ATR on Quality Control Check Report. (Apartments)

Flat No	B-301	QC report stage	Stage-3	Sl. No.	37950
Company	MPL	Project	MPL	Phase	-
Prepared by	Sravani.K	Sign	<i>[Signature]</i>	Date	12/11/21
Project Manager	Subbareddy SV	Sign	<i>[Signature]</i>	Date	15/11/21
Receipt by QC date	12/11/21	Sign		Other	
Receipt at HO date		Sign		Other	
Checked By MD on		MD Sign		For filling	☐ Yes ☐ No

MAYFLOWER PLATINUM

Details of Additions & Alterations

Description	Direction	Owners & Developers :	Date :	Promoted by	
	N	BNC Estates	Prepared By :	Modi Properties & Investments Pvt. Ltd.	
		Project Name & Phase : Mayflower Grande	Approved By : Signature :	Soham Modi	Phone: +91-40-66335551
ELECTRICAL PLAN OF FLAT-B1				N.T.S

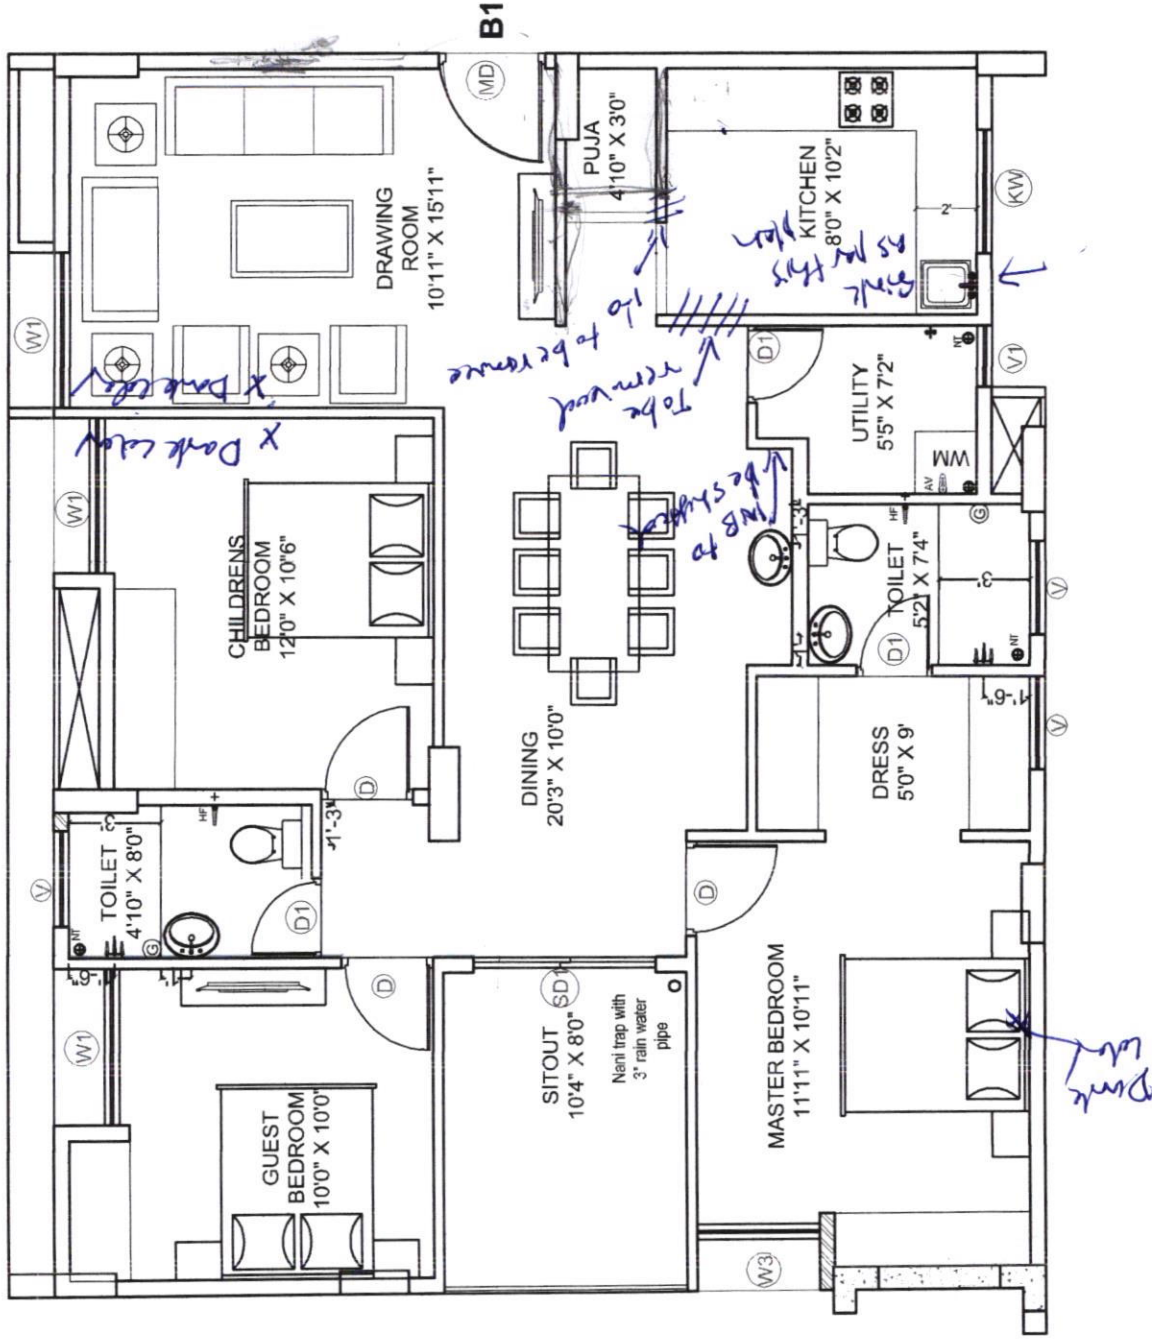
Changes in electrical points: (mark on plan)

1) 1 light point in Kitchen

2) TV pt on drawing or east wall.

Description	Direction	Owners & Developers :	Date :	Promoted by
PLUMBING PLAN OF B1	N	Modi Properties Pvt. Ltd.	09.01.2020	Modi Properties & Investments Pvt. Ltd.
		Project Name & Phase :	Prepared By :	
		Mayflower Platinum	Approved :	
			Scale :	
			N.T.S	Phone:+91-40-66335551

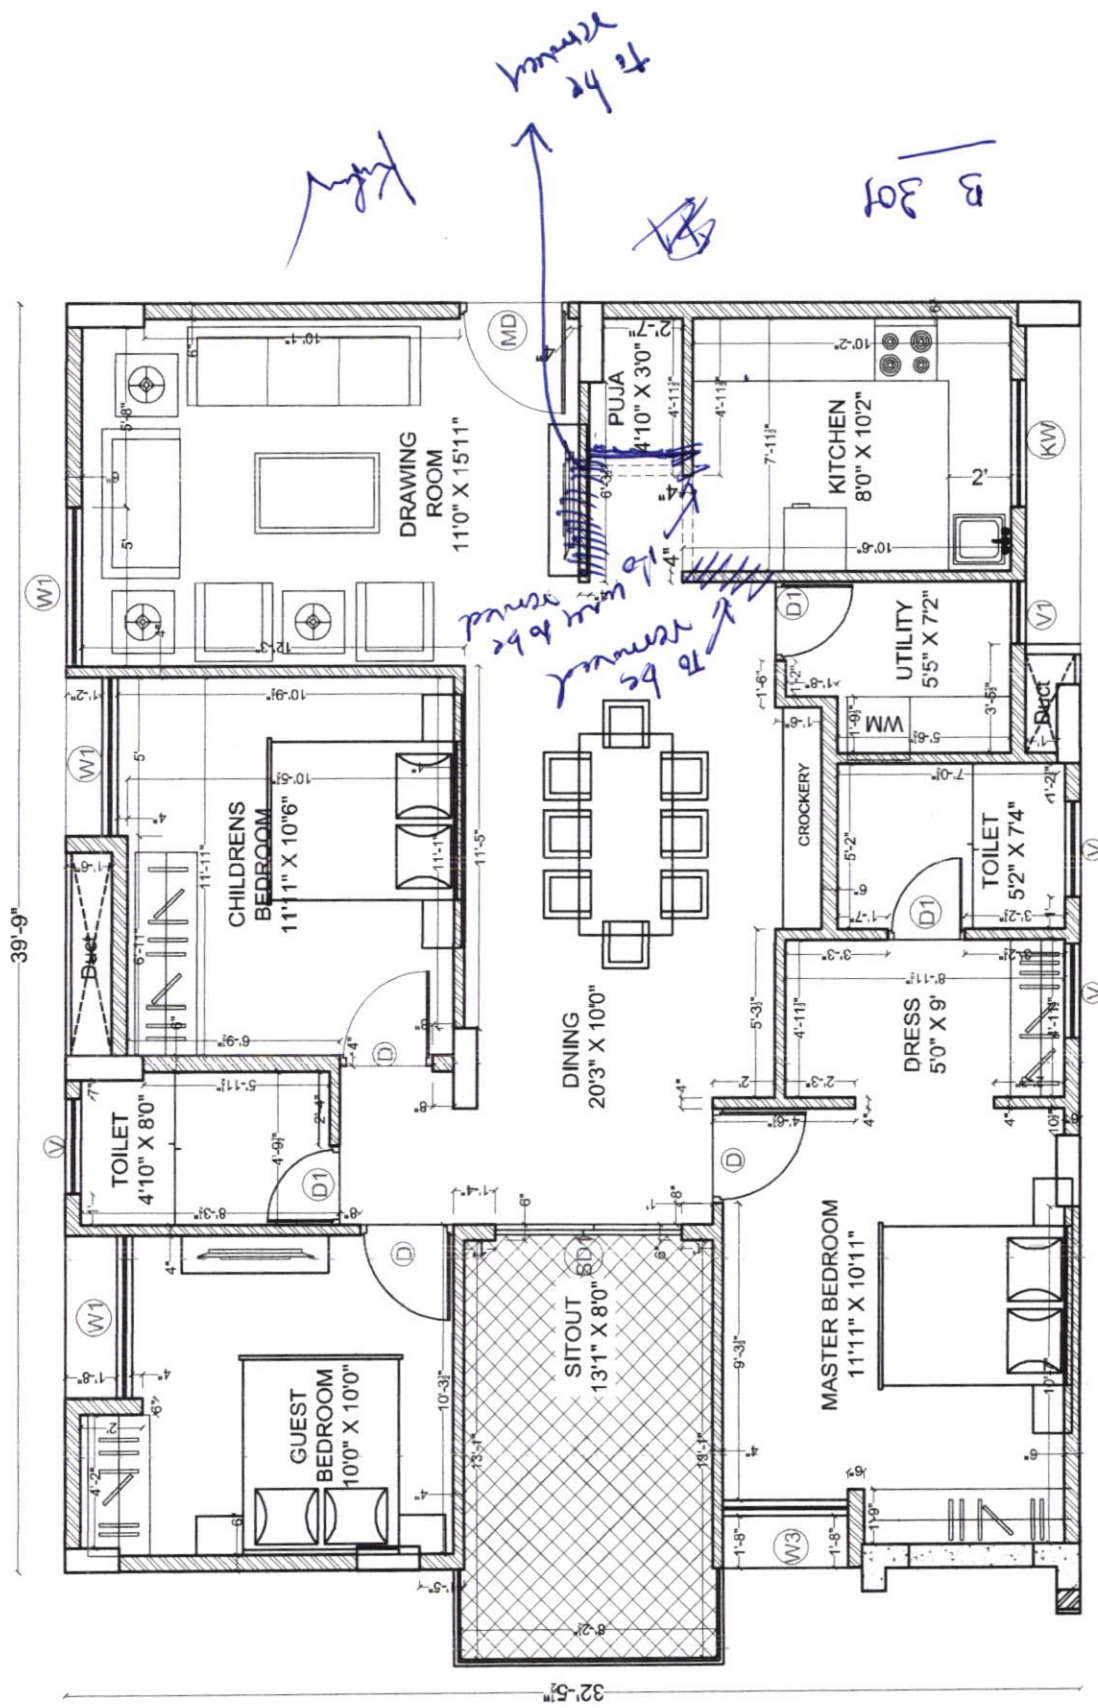
Choice of Bathroom tiles, CP fittings & Sanitary ware:

① Bathroom tiles same as P-105 model mgt
tailor in both the Bathrooms.

② Wash Basin will be brought by customer. X

Changes in kitchen platform: (mark on plan)

- ① Same as model plot A-105, sink to be shifted to . Southwest corner.
- ② SS sink will be brought by customer
